APPROVED MINUTES OF THE MEETING OF
HERITAGE WESTERN CAPE,
BUILT ENVIRONMENT AND LANDSCAPE PERMIT COMMITTEE (BELCom)
Held on Wednesday, 29 May 2019 in the 1st Floor Boardroom at the Offices of the Department of Cultural Affairs and Sport,
Protea Assurance Building, Greenmarket Square, Cape Town scheduled for 09:00

16 Osborne Street, Claremont

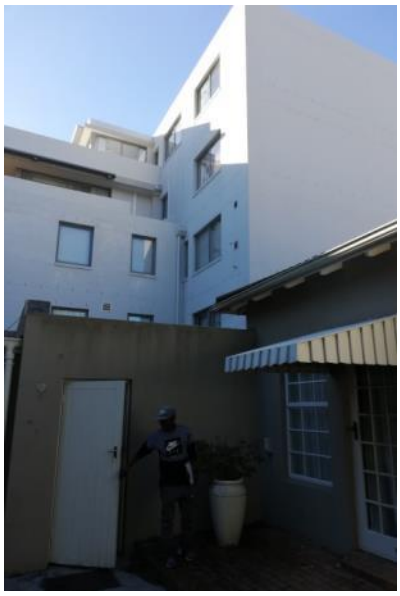
16 Osborne Street is a south facing dwelling located two city blocks off Main Road. A single story house remnant of the 1930's housing typology in the Claremont area. While the building has been altered over time and located within a 'compromised area', it somehow retained its single story scale and character. A five storey apartment block flanks the building to the east at the corner with Grove Street, with a two storey dwelling to the west, along Osborne Street.

Courtyard Kitchen entry: Change wall thickness section

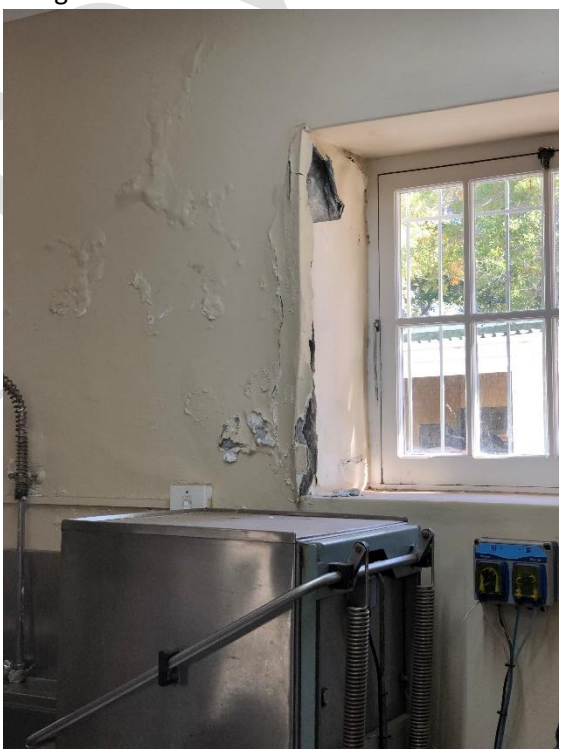
Michaelis House (originally Montebello) is of very high local historical and architectural significance with CoCT grade IIIA.
The site visit confirmed that the first-floor minor alterations are acceptable.
The area where the main changes are proposed is on the ground floor in the rear double-storey wing of the main U-shaped house toward the north.
This area has had a number of interventions, where the central mid-courtyard has been partially roofed and where the present kitchen and a passage and the rear staircase layouts are somewhat different to the plans 1953 PWD provided in the heritage report.
These old plans appear to be the only historical information available (tbc) to guide the present attempt to improve the admittedly rather awkward ablution arrangement. There are a number of different wall thicknesses, both in plan but also in section, making the historic reading of this part of the building quite difficult.

FURTHER REQUIREMENTS:
The Committee supported the proposal in principle but required further refinement of the drawings with respect of the points raised: namely floor levels and window positions.
